Title: TE0889		
A4	Number: TE0889 Default	Rev. 03
Date: 2020-12-01	Copyright: Trenz Electronic GmbH	Page 1 of 4
Filename: TE0889.SchDoc

CHANGES REV01 to REV02

Title: TE0889 - Changes list		
	A4	Number: TE0889 Default	Rev. 03
	Date: 2020-12-01	Copyright: Trenz Electronic GmbH	Page 4 of 4
	Filename: Revision_Changes.SchDoc

Title: TE0889		
A4	Number: TE0889 Default	Rev. 03
Date: 2020-12-01	Copyright: Trenz Electronic GmbH	Page 2 of 4
Filename: FTDI.SchDoc

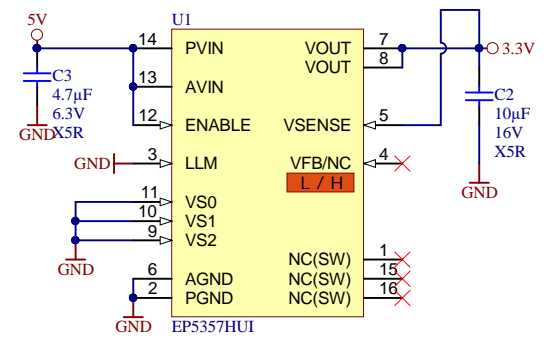
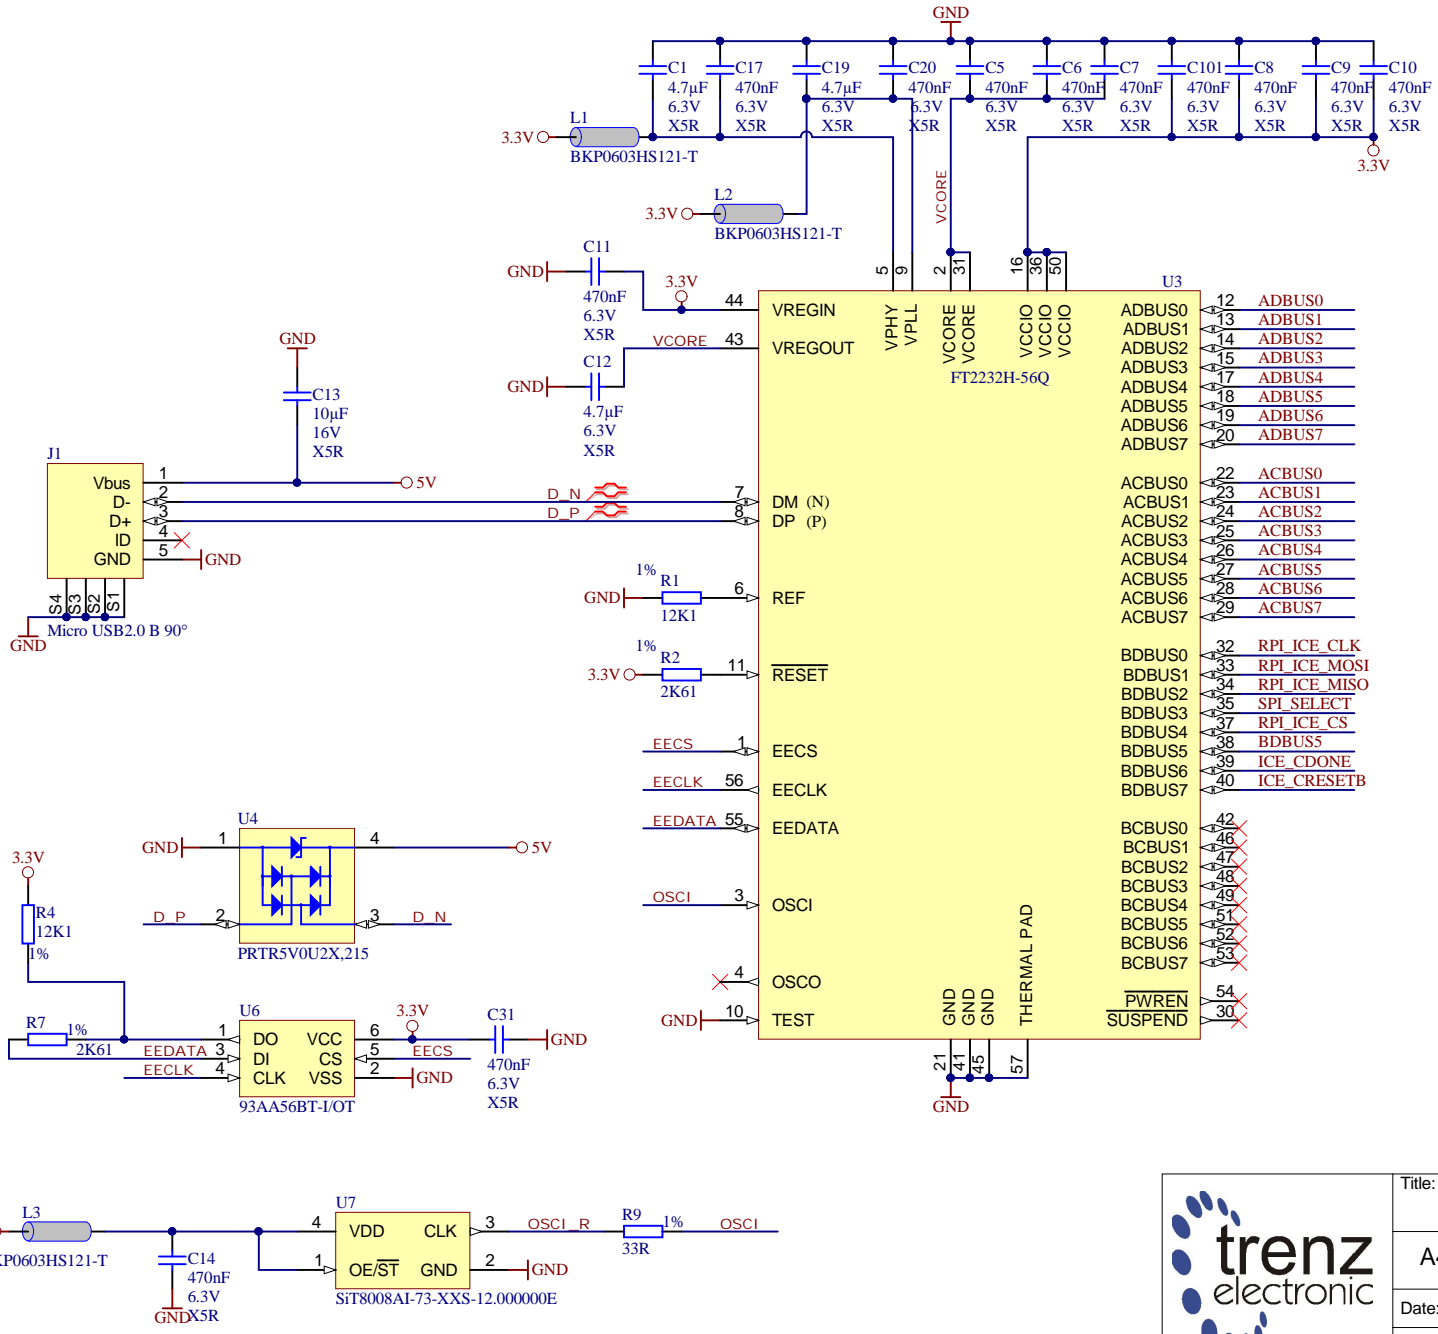
- VT: 1) Full upd Lib
- VT: 2) Replaced EOL DCDC component (U1, LXDC2HL33A-055 -> EP5357HUI)
- VT: 3) Replaced fiducials
- VT: 4) Changed silkscreen on PCB
- VT: 5) Removed EOL Track-it™ Traceability Pad

Title: TE0889		
	A4	Number: TE0889 Default	Rev. 03
	Date: 2020-12-01	Copyright: Trenz Electronic GmbH	Page 3 of 4
	Filename: RPi-Headers.SchDoc

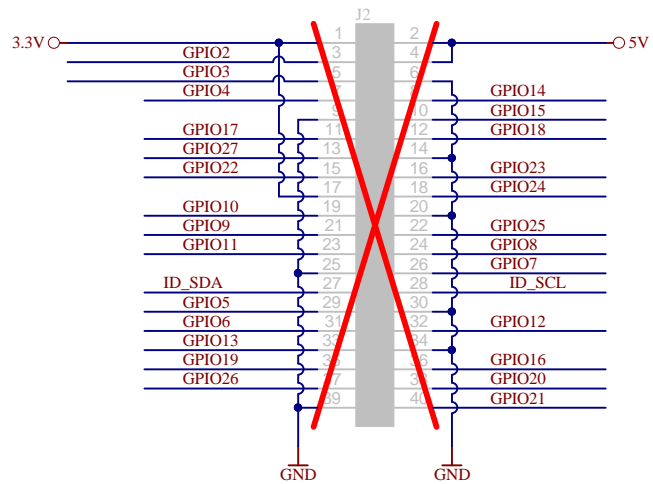
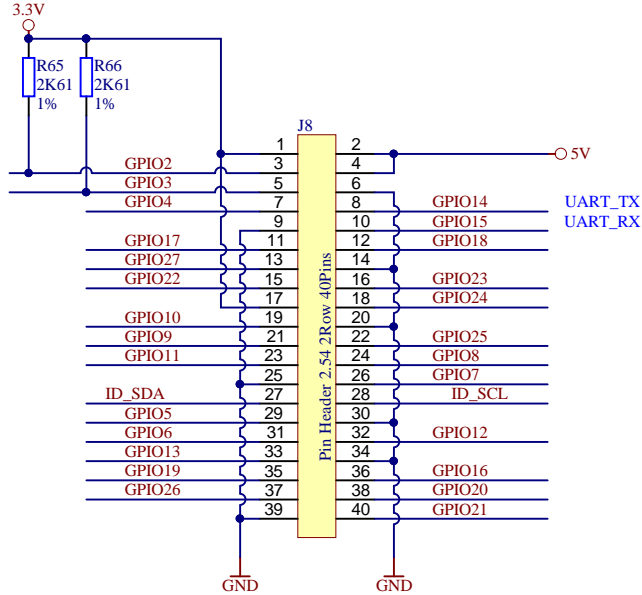
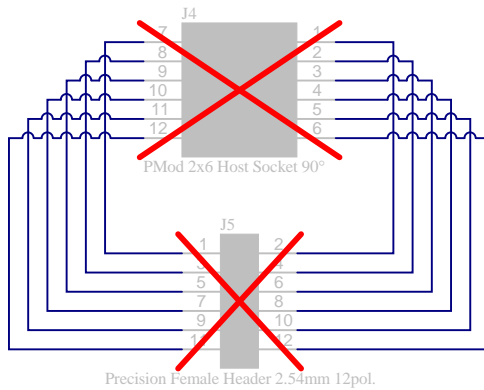
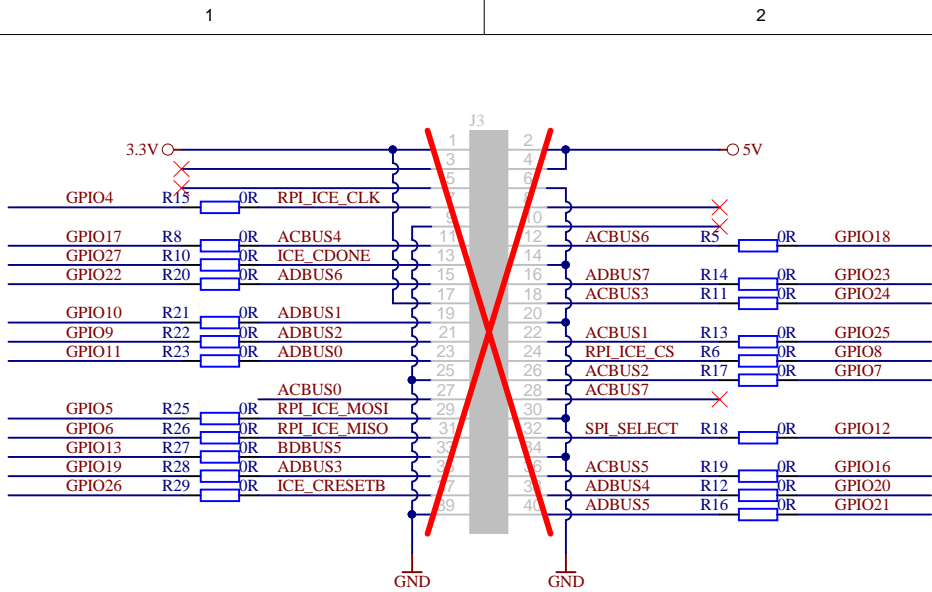
- 1) changed micro USB connector AN26783(FCI 10118194-0001LF) to AN27235 (Würth 629105150521)
- 2) full update lib
- 3) changed connection on FTDI (U3) :
 - * added:
 - a) pin27 (ACBUS5)
 - b) pin29 (ACBUS7)
 - c) pin38 (BDBUS5)
- 4) changed connection on connector J3:
 - * replaced: net ACBUS0 from pin33 to pin27
 - * added:
 - a) pin28 (ACBUS7)
 - b) pin33 (BDBUS5)
 - c) pin36 (ACBUS5)
